WASTE WATER TREATMENT PLANT  
AL KASIK MILITARY TRAINING BASE  
AL KASIK, IRAQ

**SIGIR PA-06-074**  
**JANUARY 29, 2007**

SUBJECT: Report on Waste Water Treatment Plant, Al Kasik Military Training Base, Al Kasik, Iraq (Report Number SIGIR PA-06-074)

**Diagram 1. Diagram from contractor's submittal A-106 for clarifier torque calculations. The diagram does not show a vertical skimmer arm attached to the sweep arm.**

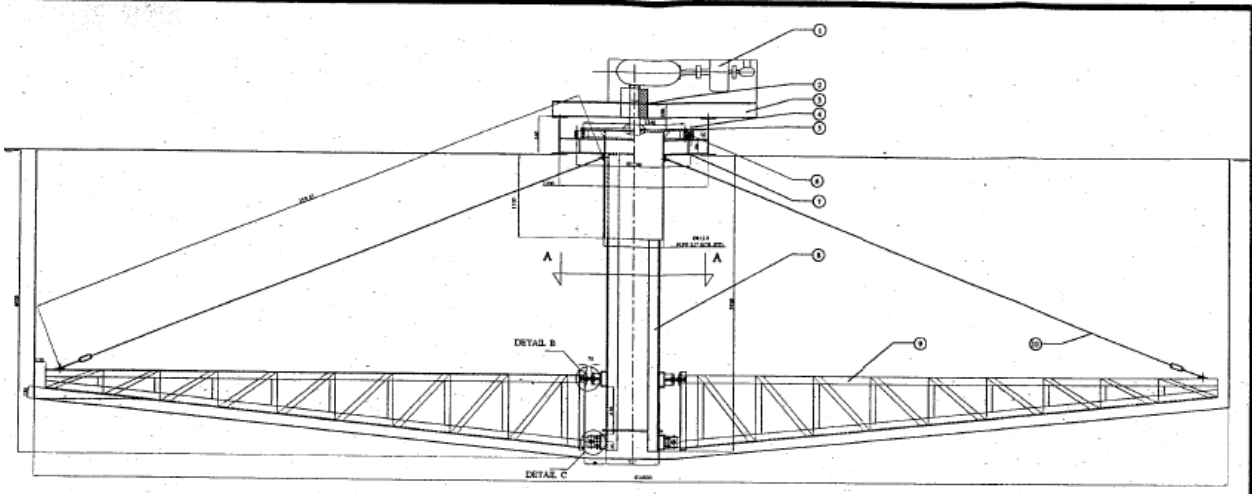
*“My engineers are not aware of a revision for these arms. Looking at the previous photos and original drawings, the only conclusion we can draw is that (the Iraqi subcontractor)<sup>2</sup> picked up an old frame and fabricated a second to stiffen the frame. This could be the confusion. “*

In that the skimmer structure was not part of the original design, engineering load calculations were likely understated. Changes in the design, such as the addition of the skimmer structure, altered the boundary conditions for the original torque analysis of submittal A-106. The absence of a properly calculated design change to account for the addition of the skimmer structure during construction was likely the catalyst for the series of failures that rendered the clarifier tank inoperable.

**Diagram 2. An unbalanced load on the horizontal arm assembly caused stress on the vertical shaft which forced the shaft to an off center position.**

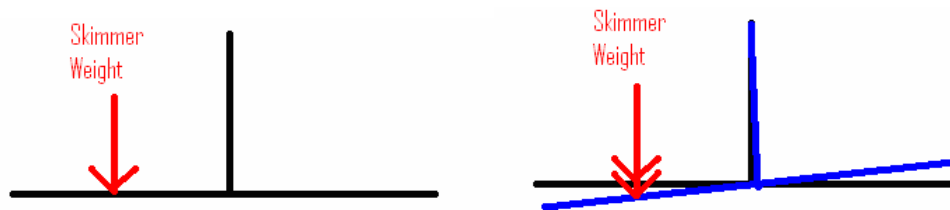
The off center vertical shaft was an indicator of an asymmetrical shaft load. The main shaft moved from center because of an unbalanced load caused by the added weight of the vertical skimmer structure attached during construction to one side of the horizontal scraper arm assembly. Conversely, the opposite side of the horizontal scraper arm assembly did not include a counterweight to offset the weight of the skimmer structure and unbalanced state of the horizontal sweep arm. In addition, an undetermined amount of additional drag force was created as the skimmer structure moved through the tank's liquid while the horizontal sweep arm assembly rotated. Accordingly, the overall load placed on the horizontal sweep arm assembly and drive gearbox likely increased substantially by the addition of the vertical skimmer structure. Simply put, the vertical skimmer structure attached during construction was big and heavy and caused the structure to be unbalanced. Diagram 2 illustrates the movement of the vertical shaft because of the unbalanced load on the horizontal sweep arm assembly. QA Photo 10 presented later in this report shows the skimmer assembly from the top while Site Photo 7 shows the skimmer from inside the tank.

**Diagram 3. Pump Station G-03 from contractor's piping plan drawing.**

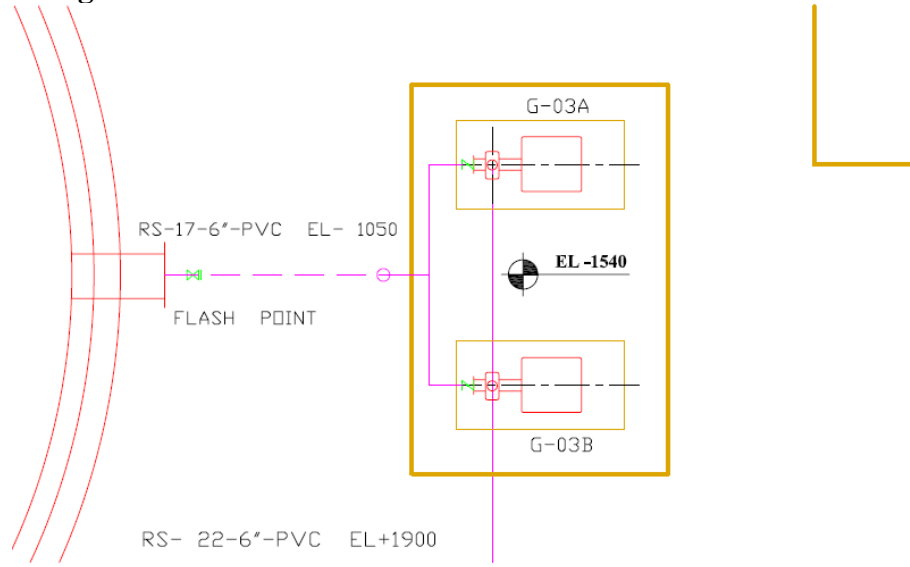
The G-03 pump station located beside the D-07 tank consisted of a below grade reinforced concrete pad with foundation walls. Placing the pumps below grade improved the efficiency of the pumps located on pads identified as G-03A and G-03B in Diagram 3. In addition, the diagram shows the relative location of the pump station in relation to the edge of the D-7 tank. In comparison to many of the concrete structures observed throughout the WWTP, the G-03 pump station was not a large structure. It measured approximately, 4.4 m (14.5 ft) by 2.7 m (9 ft) by 1.7 m (5.6 ft) deep. During the site visit, the assessment team observed significant fractures in the concrete structure along the base, walls, and corners of the G-03 pump station. A series of photos (Site Photos 11-18) illustrate what the assessment team observed while on site. Site Photos 11-16 were taken from inside the pump station while Site Photos 17 and 18 were taken from the outside.

Site Photos 11 and 12 show that sizeable vertical cracks crept up the rear wall of the pump station.

Site Photos 13 and 14 show the horizontal fracturing that occurred near the base of the structure and at a point approximately half way up the wall. The horizontal cracks were generally parallel to each other. Site Photos 15 and 16 show very similar horizontal cracks that wrapped around the opposite corners in the rear wall of the pump station.

During fieldwork discussions, the AFCEE/COR agreed that the pump station should be reconstructed to prevent continued degradation of the pump station and as a hedge against future failure in the G-03 pump station.

Diagram 4. Cross section of G-03 building from the contractor's A-41 submittal.

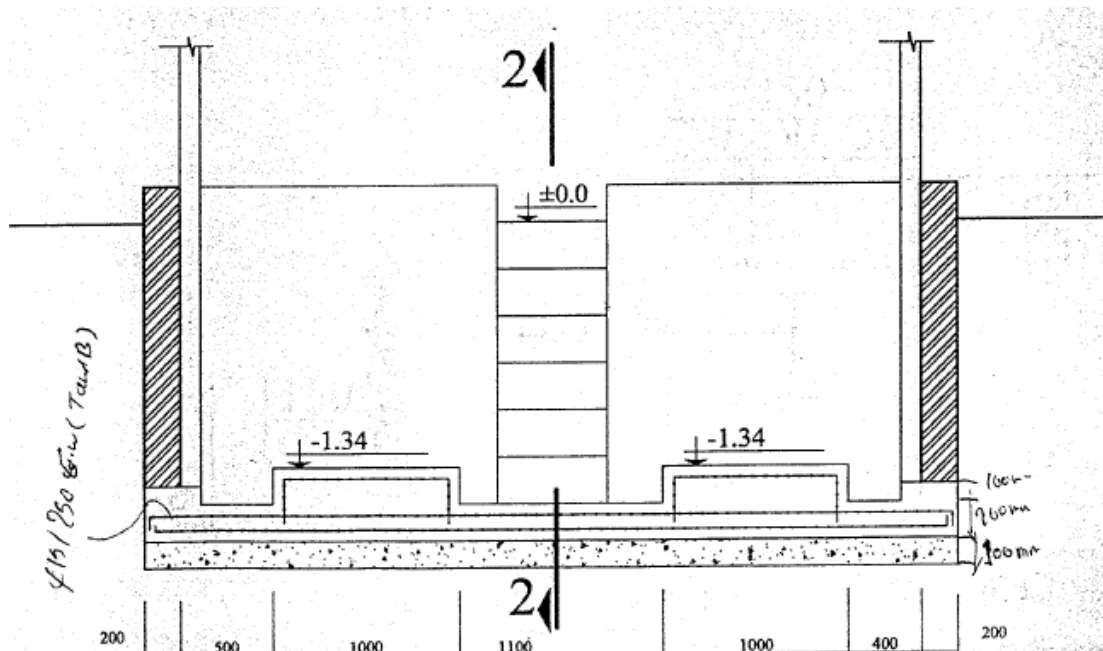
During a review of design and Quality Control documentation, the assessment team found contractor's submittal A-41, G-03 pump pad details, (Diagram 4) with comments that specified the BRC #63 should be replaced with steel bar reinforcement.

Based on the assessment team's observations, a review of design and QC documentation, and discussions conducted with the CMATT/RSU Engineer and the AFCEE/COR, the number of cracks of such magnitude indicated that abnormal stress was distributed across the rear concrete wall of the structure. In addition, such cracks were likely caused by, either/or a combination of, insufficient steel reinforcement of the concrete or inadequate soil compaction. The horizontal cracks that ran from corner to corner of the rear wall indicated that settling of the base slab was very likely. Inadequate soil compaction could cause such settling. Even if properly reinforced, much less if not sufficiently reinforced, the concrete wall would have been prone to cracking if constructed on soil that was not sufficiently compacted.
